Steinborn Residence

Date:
2/19/2023 Permit Approval
8/24/2023 Permit Rev. Sub
12/6/2024 Permit Rev. Sub

CHEN RESIDENCE

New Residence

Main Level
Floor Plan

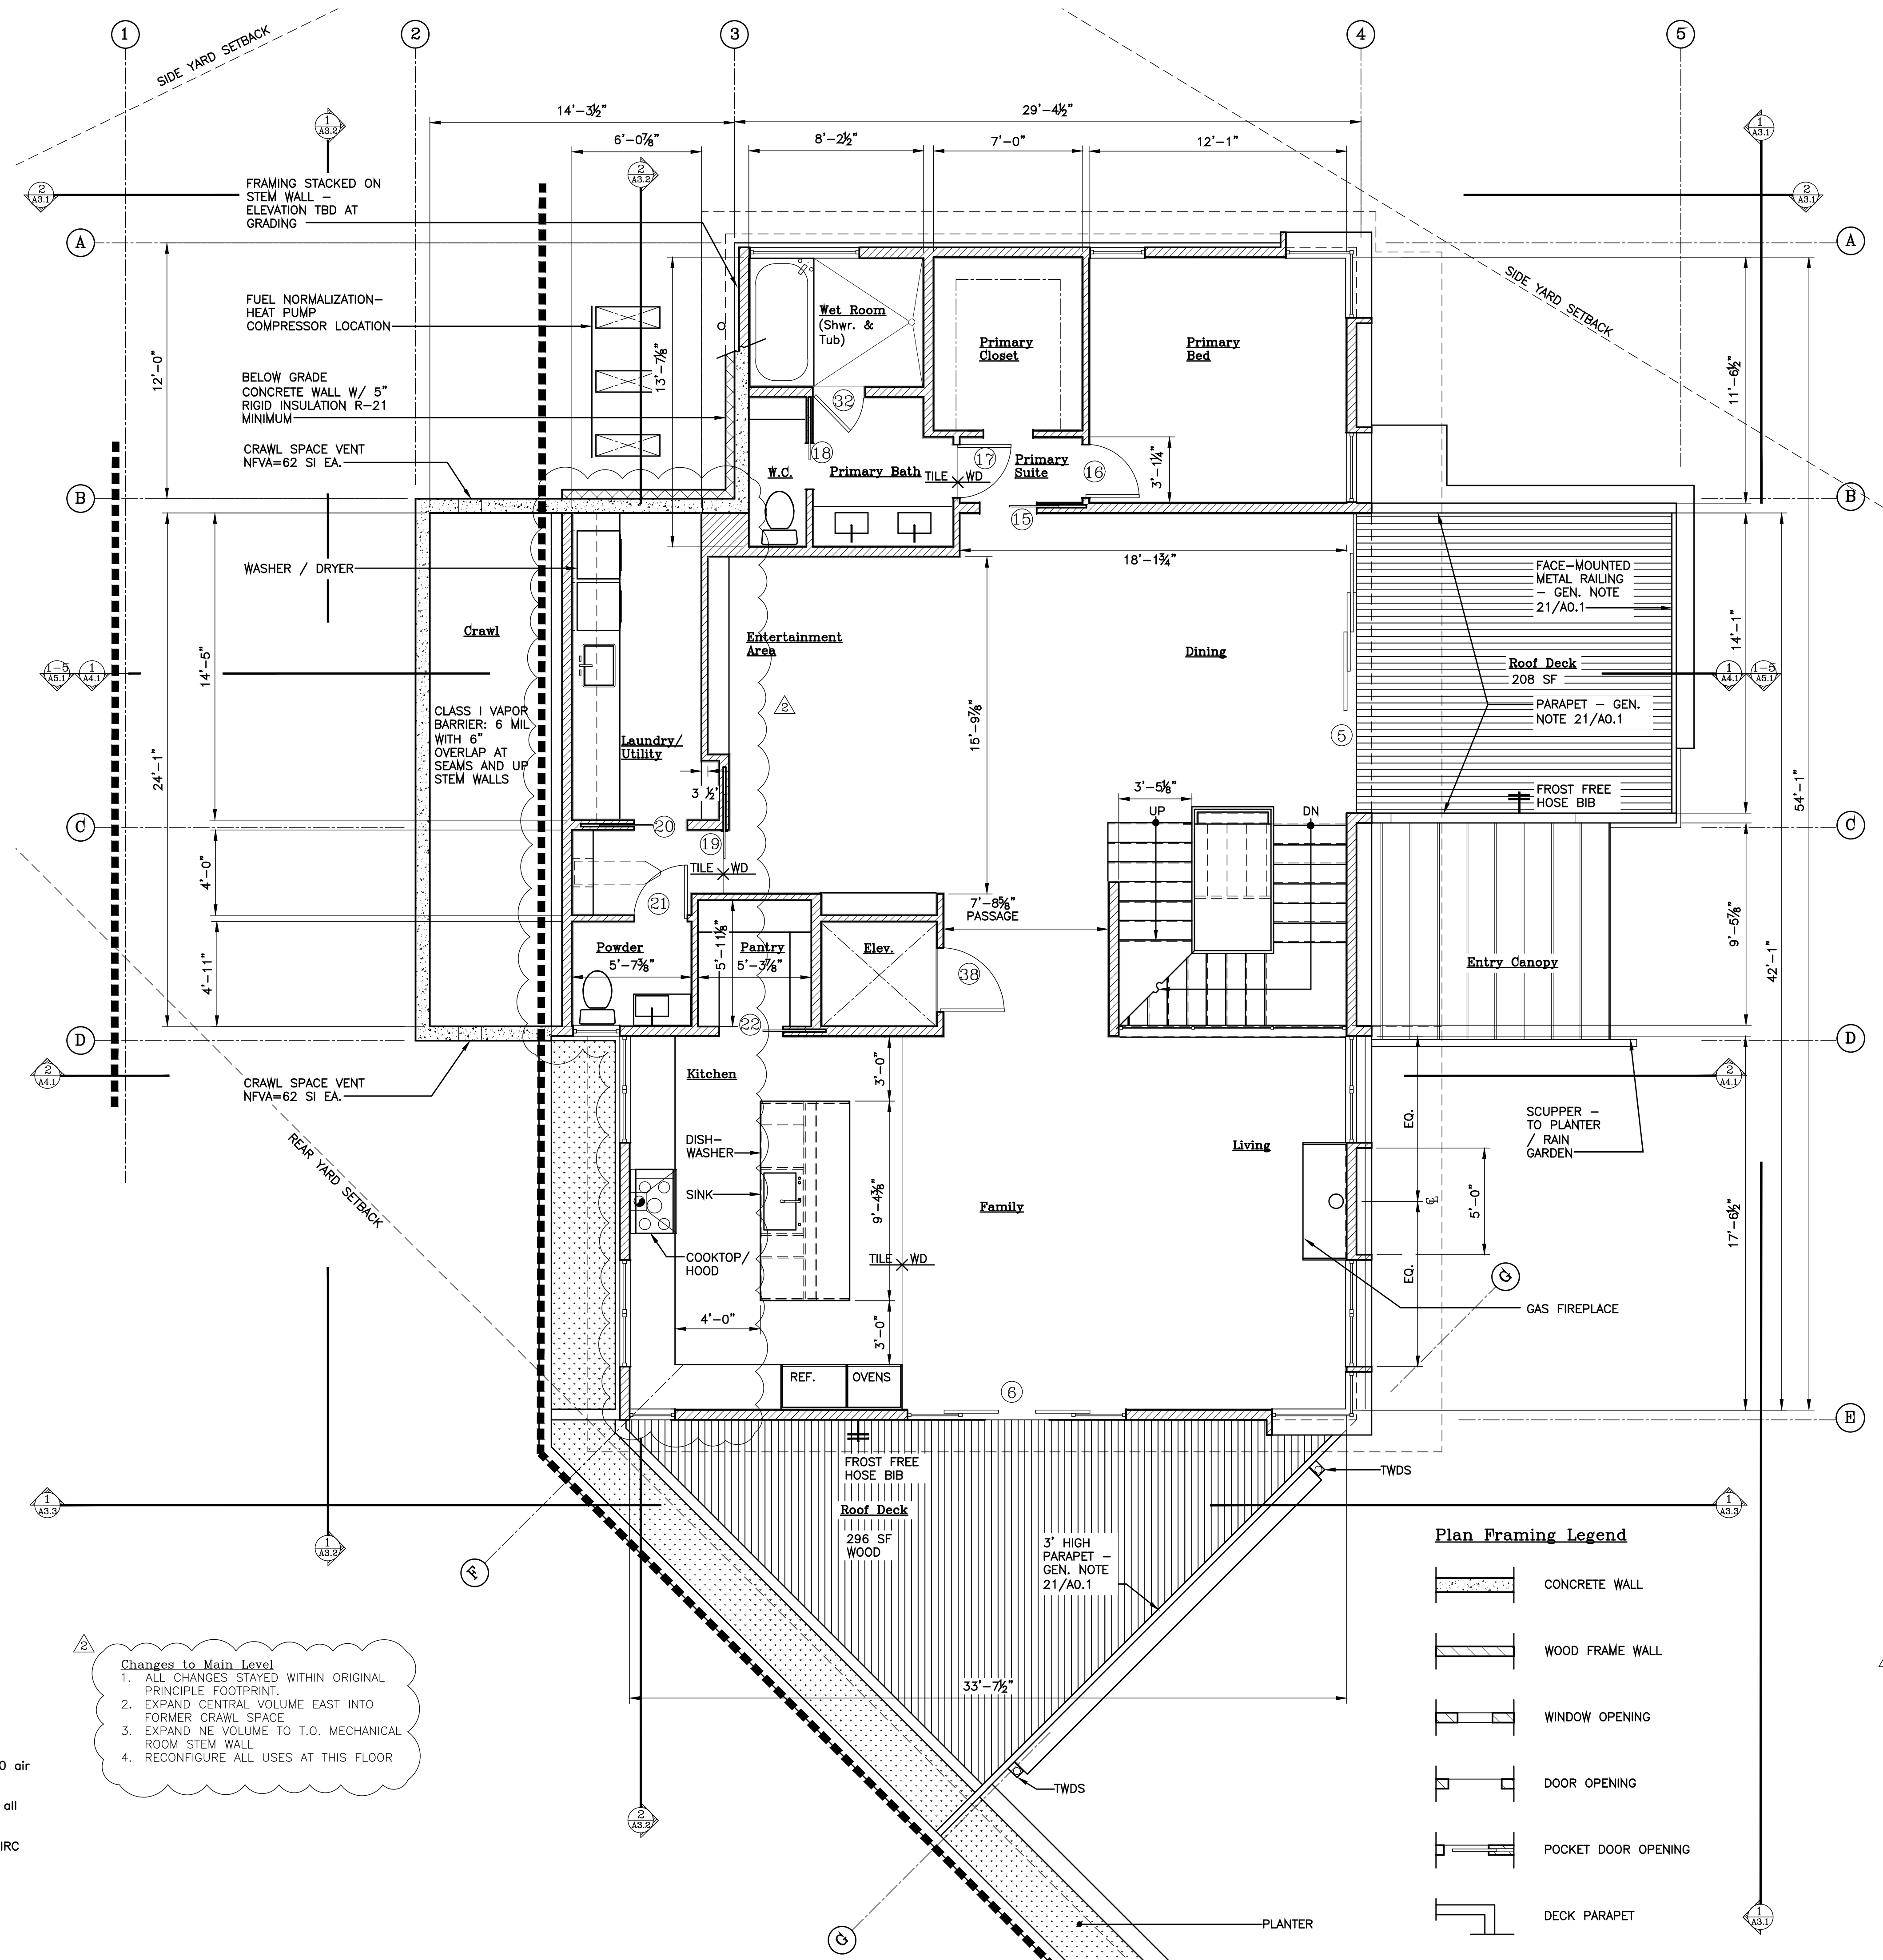
Changes to Main Level

1. ALL CHANGES STAYED WITHIN ORIGINAL PRINCIPLE FOOTPRINT.
2. EXPAND CENTRAL VOLUME EAST INTO FORMER CRAWL SPACE.
3. EXPAND NE VOLUME TO T.O. MECHANICAL ROOM STEM WALL.
4. RECONFIGURE ALL USES AT THIS FLOOR

Upper Level
Floor Plan
A2.2

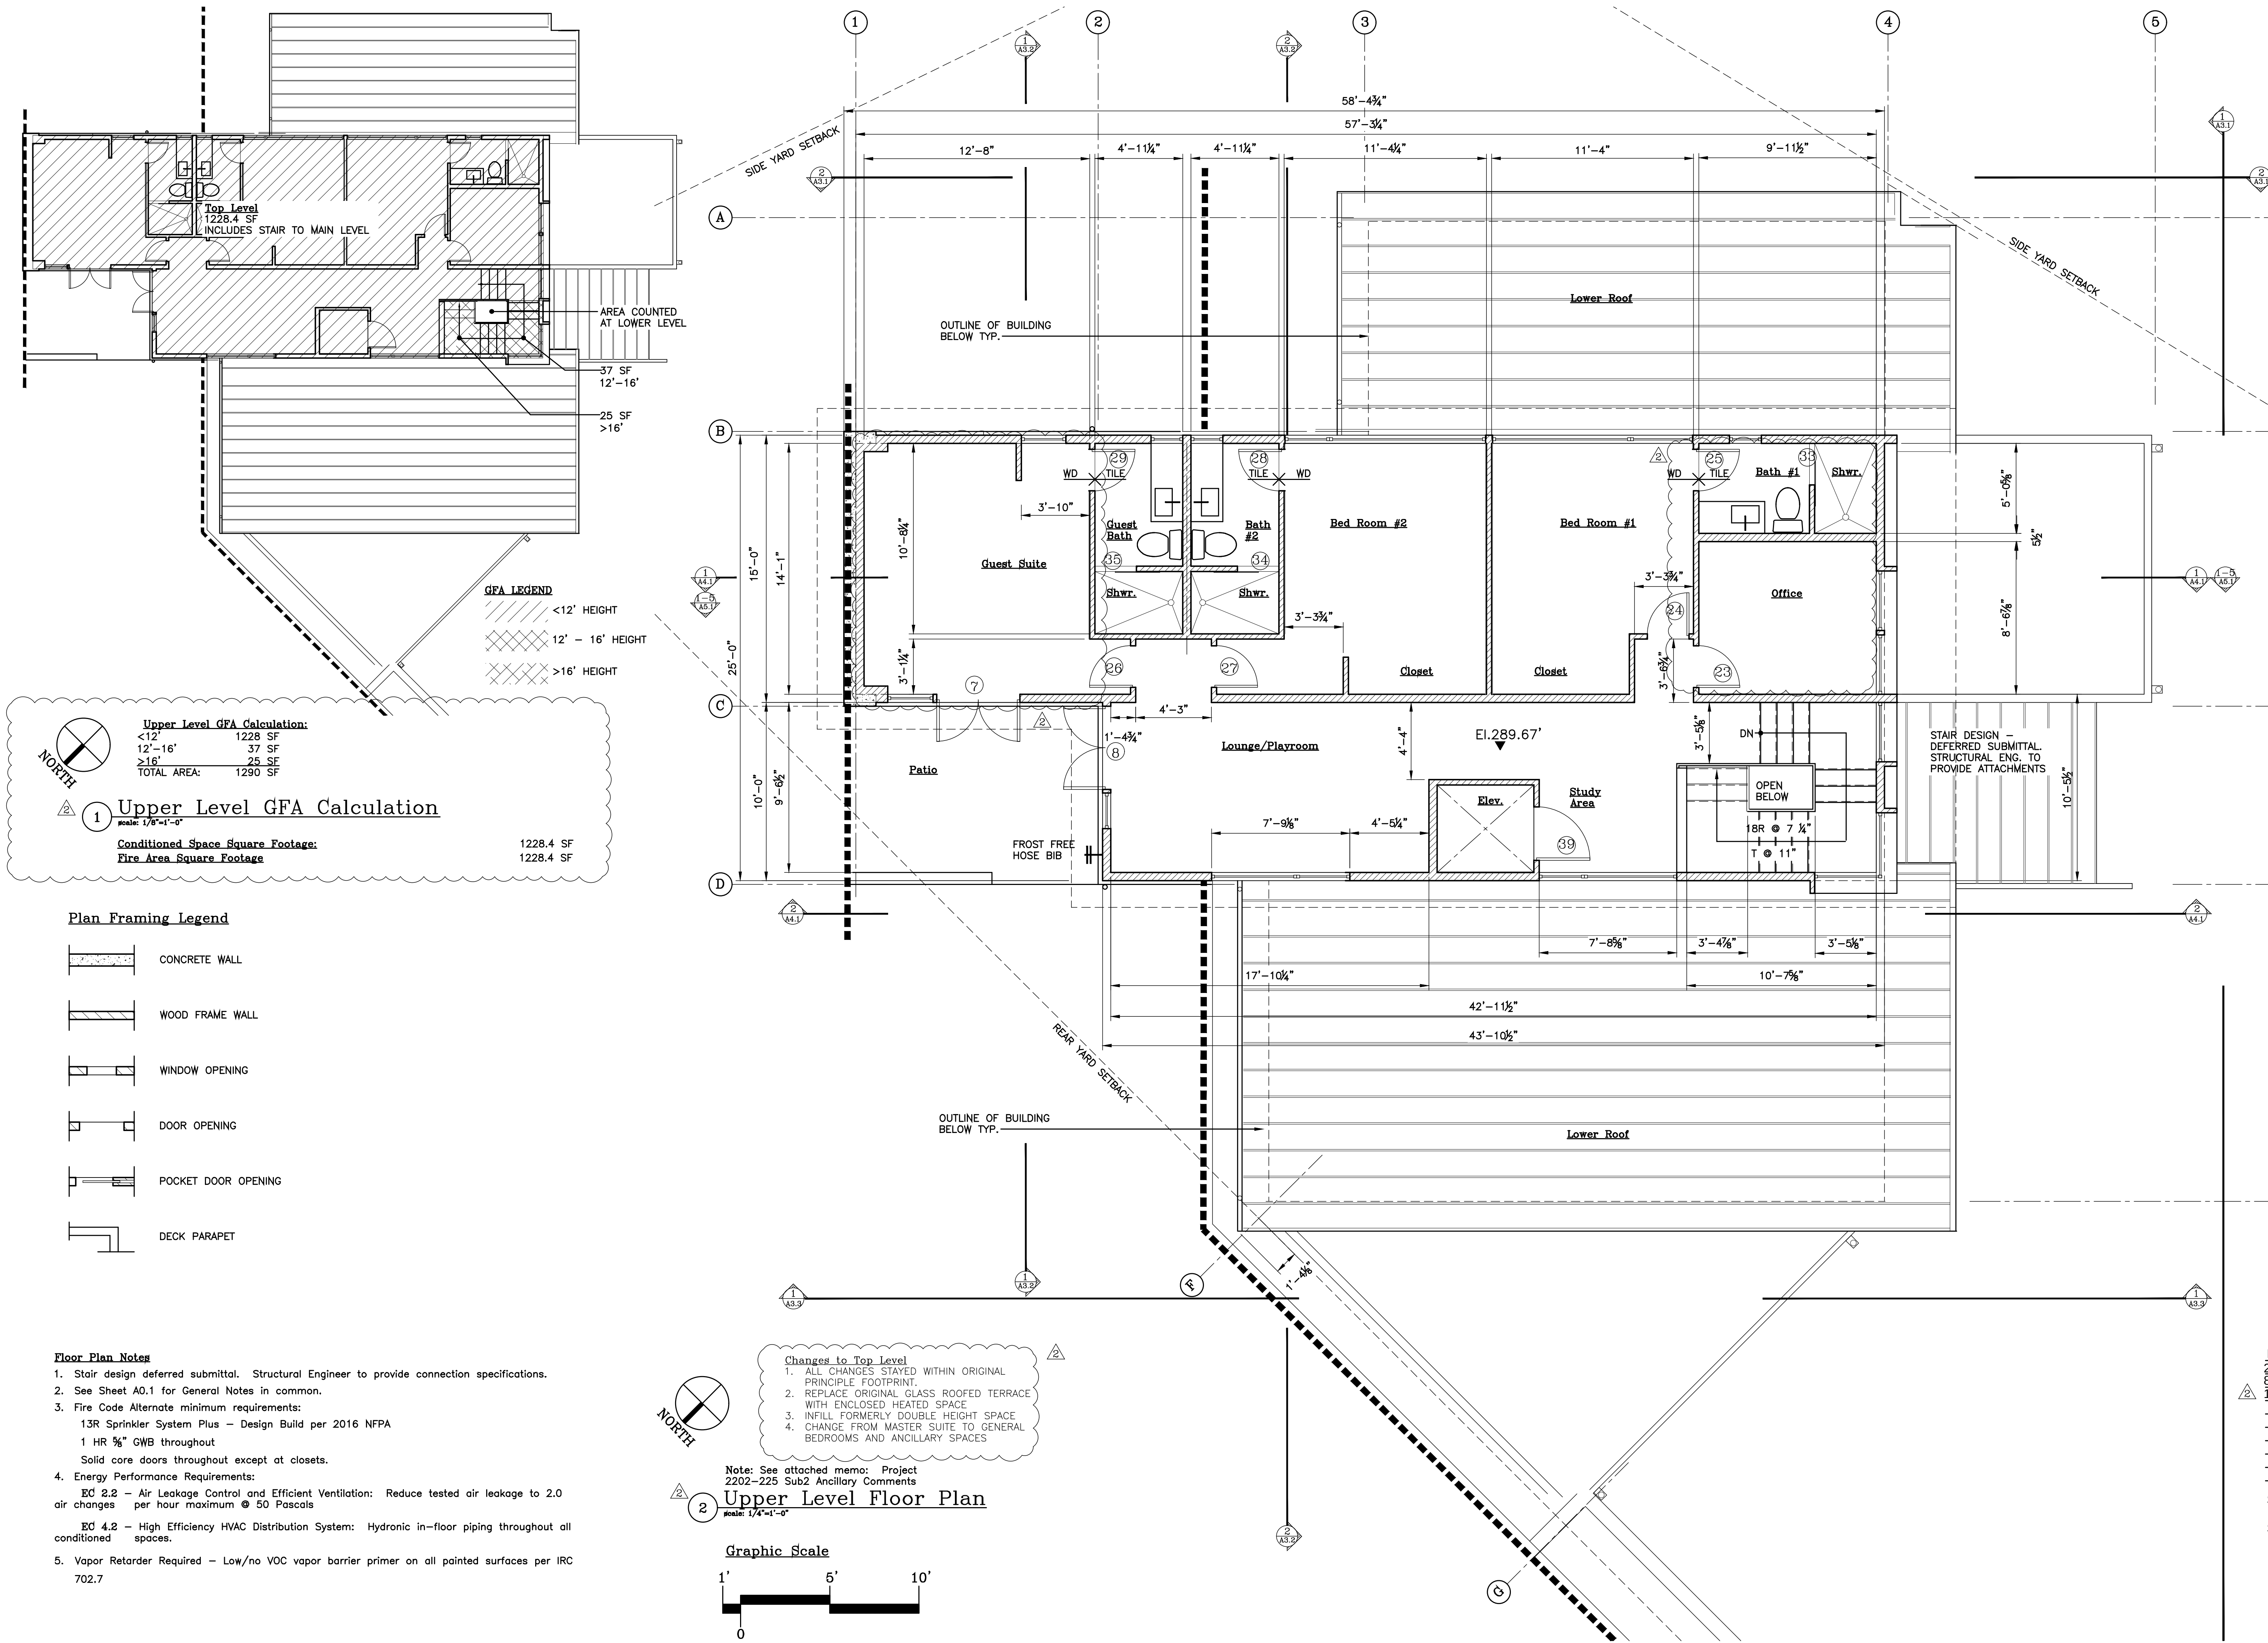
1. ALL CHANGES STAYED WITHIN ORIGINAL PRINCIPLE FOOTPRINT.
2. REPLACE ORIGINAL GLASS ROOFED TERRACE WITH ENCLOSED HEATED SPACE
3. INFILL FORMERLY DOUBLE HEIGHT SPACE
4. CHANGE FROM MASTER SUITE TO GENERAL BEDROOMS AND ANCILLARY SPACES
